Tennessee Valley Authority
Regulatory Submittal for Kingston Fossil Plant

Documents submitted:
Intake Channel Bridge Removal Work Plan (Revised)
RAWP - 087

Kingston Ash Recovery Project
Time-Critical Removal Action

Intake Channel Bridge Removal Work Plan

CONSTRUCTION HAUL BRIDGE
GENERAL ARRANGEMENT

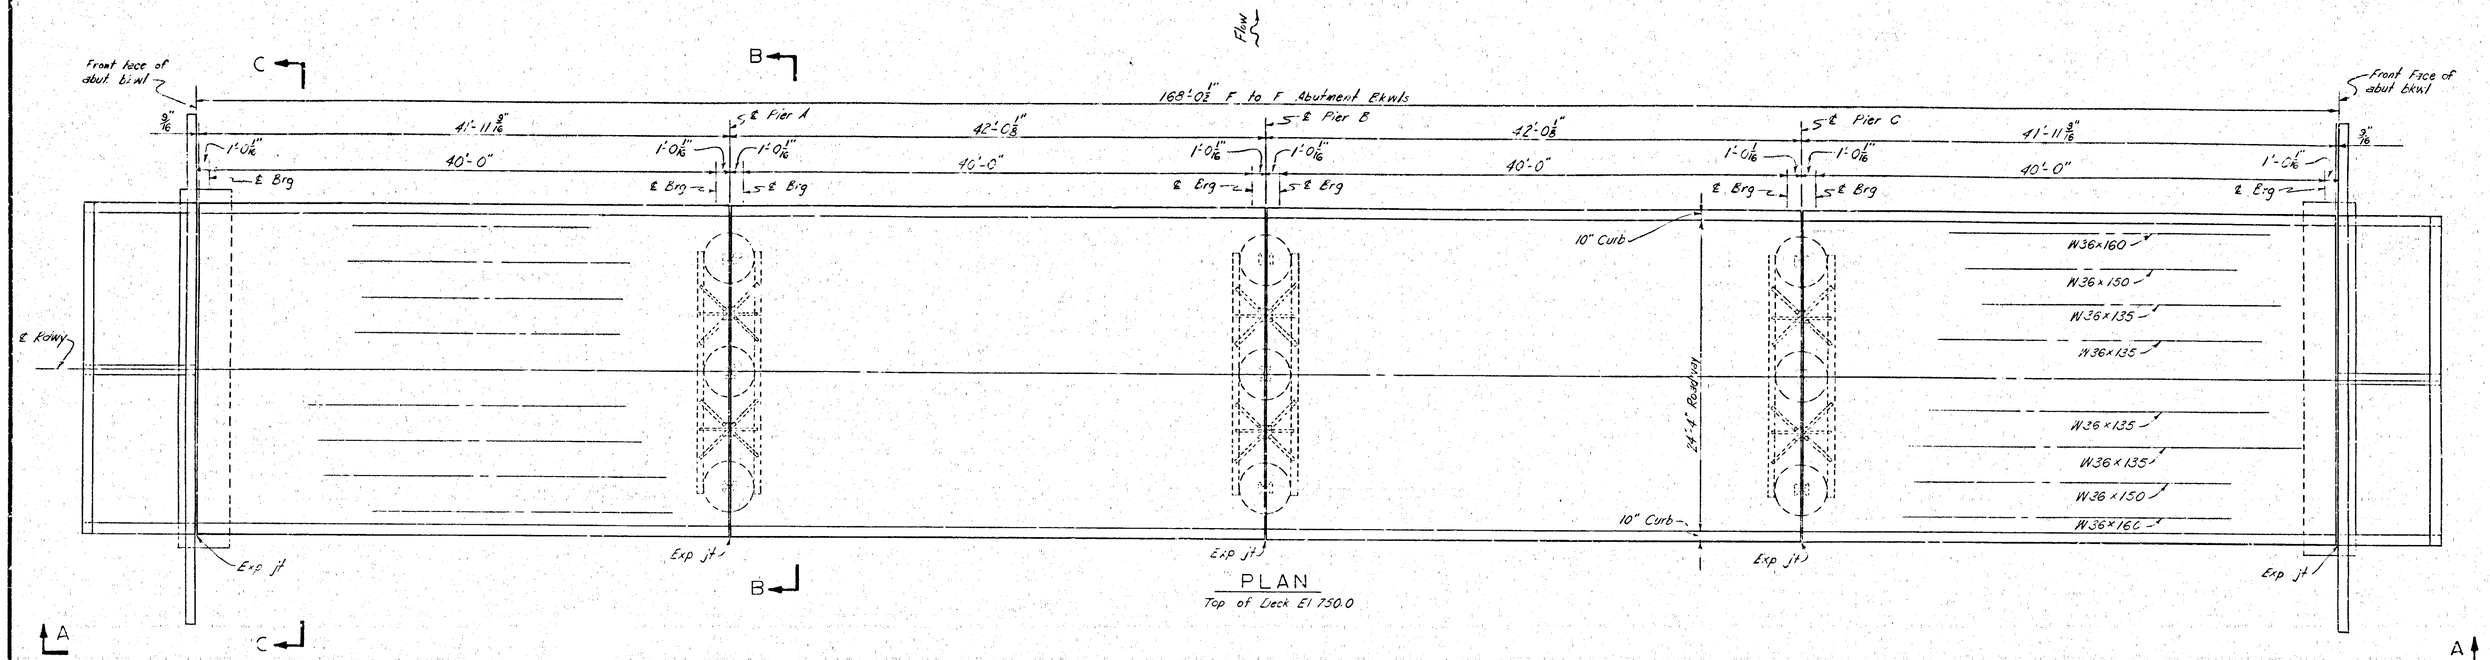
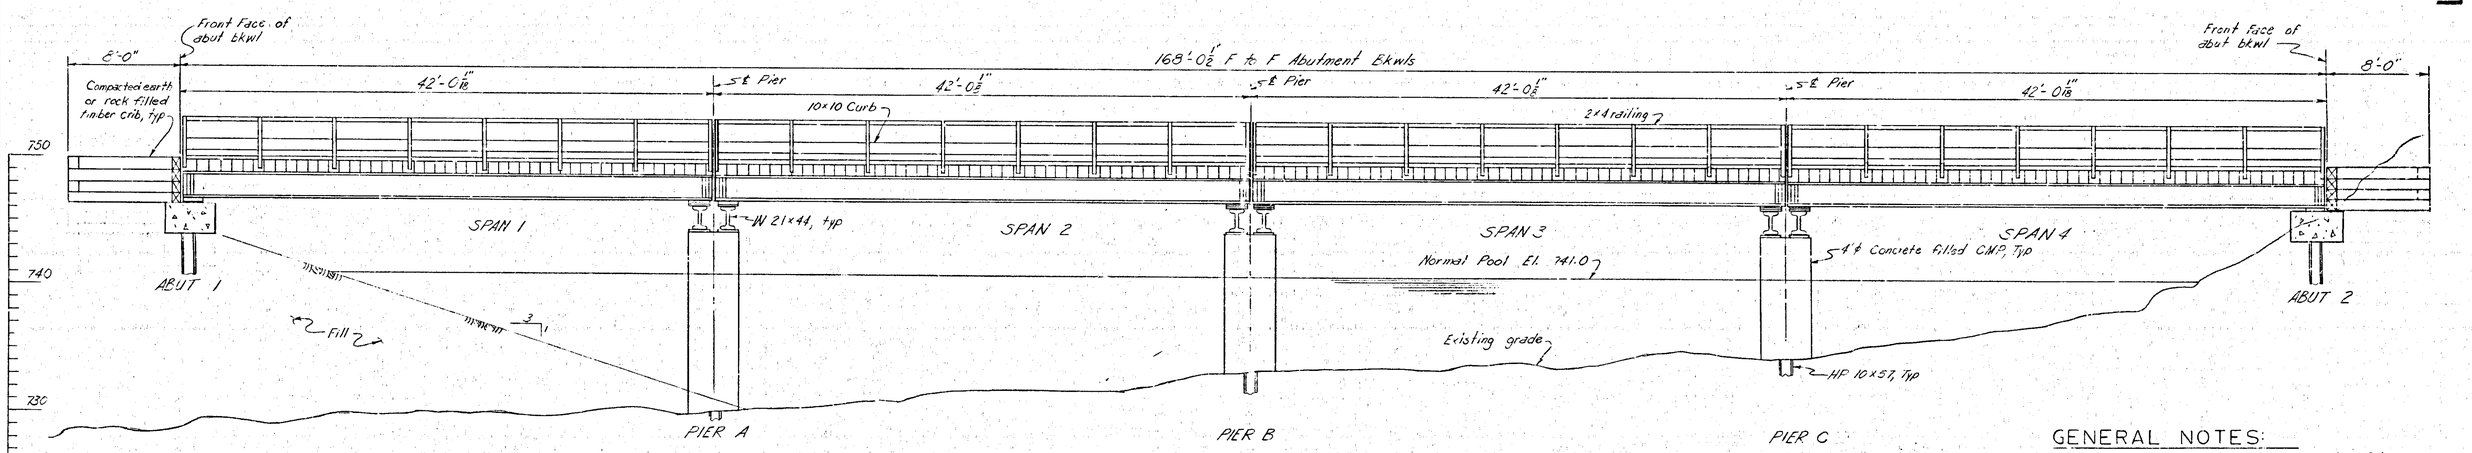
2.	Section 3.2 Piers and Abutments	Change Pier A to read Pier C as per drawing 208N1-208N7. I have hardcopy of the drawing which indicates Pier A is at the north end of the bridge. Change Pier C to Pier A. Piers B and C could be pulled using a vibratory hammer with minimal to no impact to Dike C integrity.	Please reference drawing # 208N1- note flow arrow at the top of drawing and it is assumed the flow is to the plant. Pier A is the south pier and Pier C is the north pier.

Please reference drawing # 208N1- note flow arrow at the top of drawing and it is assumed the flow is to the plant. Pier A is the south pier and Pier C is the north pier. Pier A and the south abutment will be removed by the bridge removal and demolition contractor after the decking and sub-structural steel has been removed. The north abutment, including piles, will remain in place to ensure stability of the dike. Piers B and C will and be left in place.
